Interactive comment on “Change in Frozen Soils and Its Effect on Regional Hydrology in the Upper Heihe Basin, on the Northeastern Qinghai-Tibetan Plateau” by Bing Gao et al.

Bing Gao et al.

Received and published: 1 October 2017

Fig. 1.

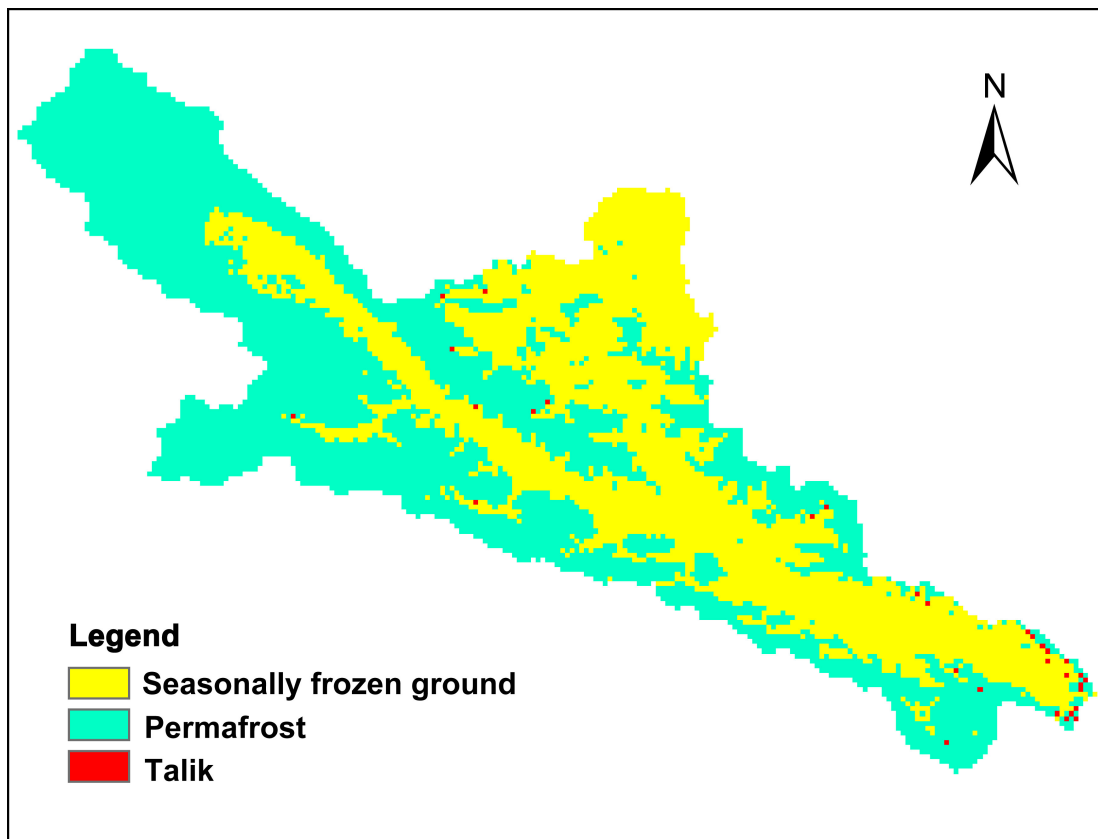
C: The paper is improved. I have only minor specific comments other than the general comment below. In general, in this paper I would like the authors to address if there is a horizontal talik above the permafrost or not. Surely there would be somewhere in

the catchment especially where the permafrost is discontinuous. Horizontal taliks exist where the maximum frost depth does not extend as deep as the maximum seasonal thaw depth. So there is a perennially unfrozen zone above the permafrost but below the active layer. Could this be significant like the conversion from permafrost to seasonally frozen ground? Would the model account for this?

A: Thanks for this comment. We have checked the results of soil temperature of each layer for all grids. We have found some taliks in permafrost region. But the horizontal taliks are not significant as shown in fig. 1.
